FINAL
ENVIRONMENTAL IMPACT STATEMENT

Village at Po'ipū

Accepting Authority,
State of Hawai'i Land Use Commission
Docket No. A05-761
Eric A. Knudsen Trust

November 2006

Figure 3
CONCEPTUAL MASTER PLAN
Village at Po'ipū

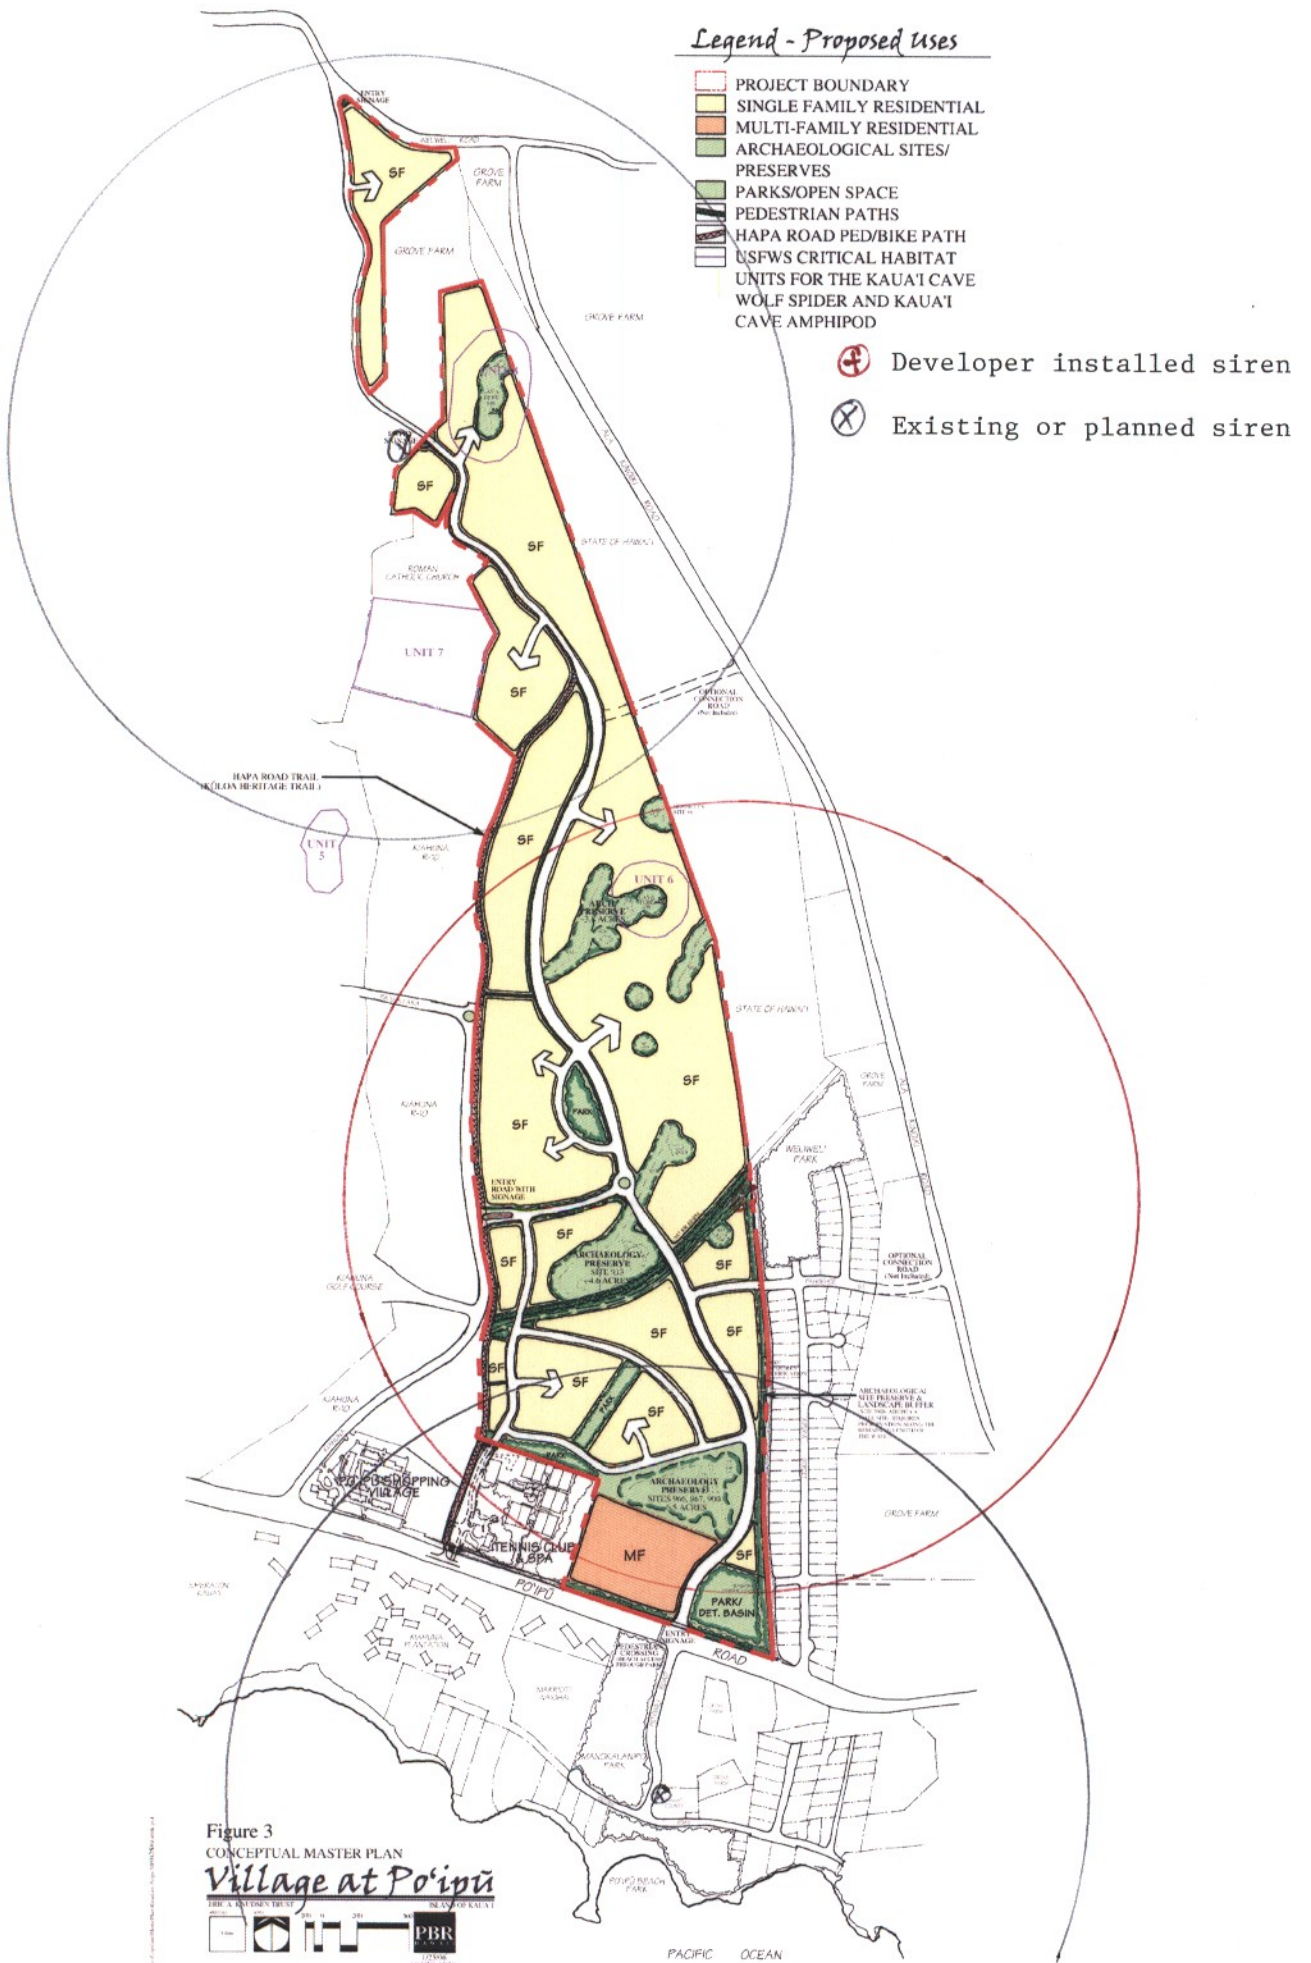
Thank you for the opportunity to comment on this Draft Environmental Impact Statement (DEIS). Having reviewed the DEIS, it is requested that the developer install a solar powered 119 Dbc siren near Weliweli Park and the berm as shown in red on enclosed Figure 3.

The increase in the number of residential units and population housed in the area caused by the development of the proposed project and petition area requires additional civil defense facilities for the area. The State Civil Defense recommends the installation of a solar powered 119 dBc siren near Weliweli Park and the railroad berm as shown in Figure 17. This recommendation is consistent with the requirements for the petition area as well since the same physical project area would need to be served by Civil Defense regardless if the additional 98 units are permitted or not. The applicant will comply with this recommendation and install the siren as proposed.
